**COMMENT ON DRAFT EIS / EIR
FOR PROPOSED CABRILLO DEEPWATER PORT**

PROJECT: Cabrillo Port Liquefied Natural Gas Deepwater Port

APPLICANT: BHP Billiton LNG International, Inc.

DOCKET #: USCG-2004-16877

Figure 1. Overlay of NOAA chart and BHPB map, showing "cheated" shipping lanes. Meridian lines of both maps are circled in green to demonstrate the accuracy of the overlay. (The page number in the legend refers to the PDF version of the DEIS/R.)

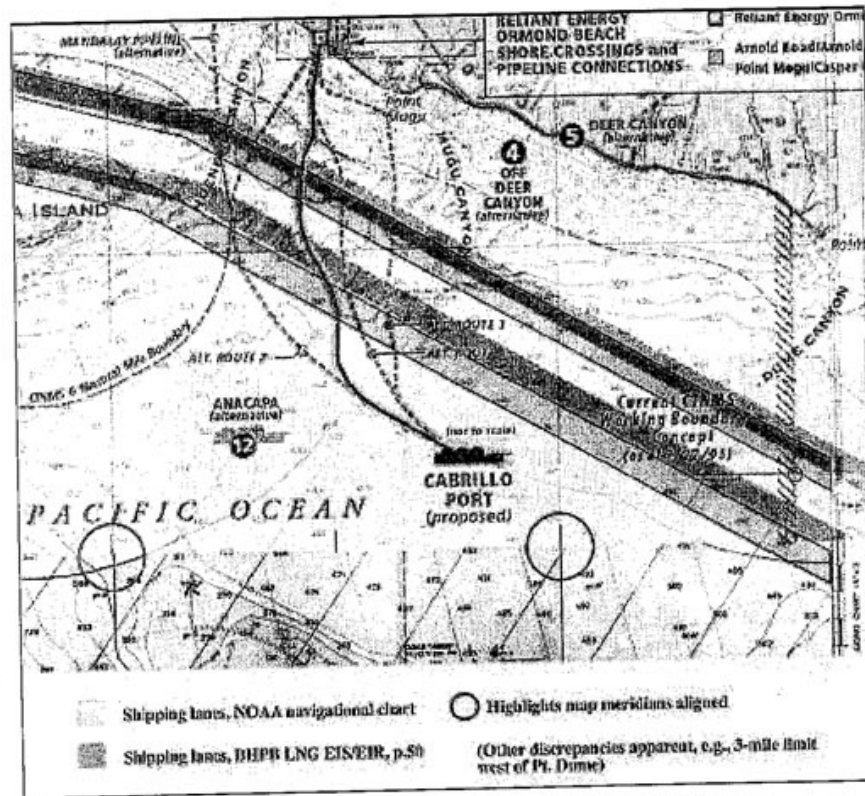
As another example of misrepresentation, overlaying a standard NOAA navigational chart⁴ on BHPB's map of shipping lanes⁵ reveals that the latter cheats, making the FSRU appear further from the shipping lanes than it would actually be.⁶ (See my FIGURE 1.) As recently as September 2004, BHPB documentation stated that "the distance to the closest edge of the shipping lane is corrected to 2.4 miles, as verified by GIS coordinates."⁷ However, the map overlay

shows that distance to be approximately 2.0 NM;⁸ and calculation using distances given in the DEIS/R confirms that the distance is 2.0 NM.⁹

Slight discrepancies are also observable in the map overlay, e.g., in BHPB's depictions of the CINMS boundary and the 3-mile State jurisdiction limit SW of Pt. Dume.

Both maps are accurate. The NOAA nautical chart uses a Mercator projection, and the regional map in the October 2004 Draft EIS/EIR (Figures ES-3 and 3.3-1) uses a Lambert conformal conical projection. On a Mercator map, longitudinal lines converge at the poles; the farther from the equator, the closer together the lines of longitude. It is not possible to successfully overlay a conical projection map on a Mercator chart without distorting shapes and distances.

Figures ES-3 and 3.3-1 are based on a map of the State of California at a scale of 1:1,000,000, a scale that permits the display of the large geographic area that has features of interest to the public. The shipping lanes were transferred from a nautical chart (scale 1:232,188, or more than four times the scale of the regional map) on a different projection. The shipping lanes are shown in more detail on other maps in the document (see Section 4.3). Both figures state, "Map depicts approximate locations based on best available data" and note that certain features are not to scale.

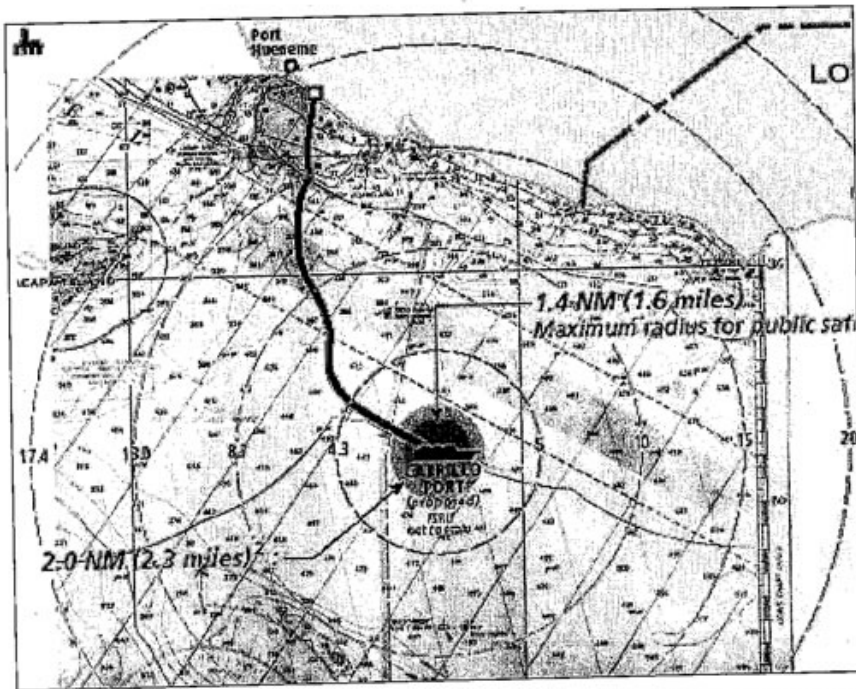
Similarly, the FSRU is stated as being 2.4 NM from the boundary of the Pt. Mugu Sea Range (Pacific Missile Range). But close measurement shows it to be 2.0 NM from the boundary. This is fairly evident in my FIGURE 2, in which BHPB's Distance Map (Figure 2.2-1) is overlaid on the same NOAA navigational chart.¹⁰ Here, the orange 2.0 NM precautionary zone directly abuts both the shipping lane and the missile range boundary. This presents significant unaddressed impacts in terms of "vessel traffic disruption" (discussed below at *Exclusion Zone and Precautionary Zone*).

Table 2.1-2 contains information on the distances from the FSRU to specific locations. Section 4.3.1.1 describes the distance from the FSRU to the shipping lanes. Sections 2.2.4 and 4.3.1.4. discuss the characteristics of the safety zone and area to be avoided.

See the response to Comment G434-2, which explains that it is not possible to accurately overlay maps in two different projections.
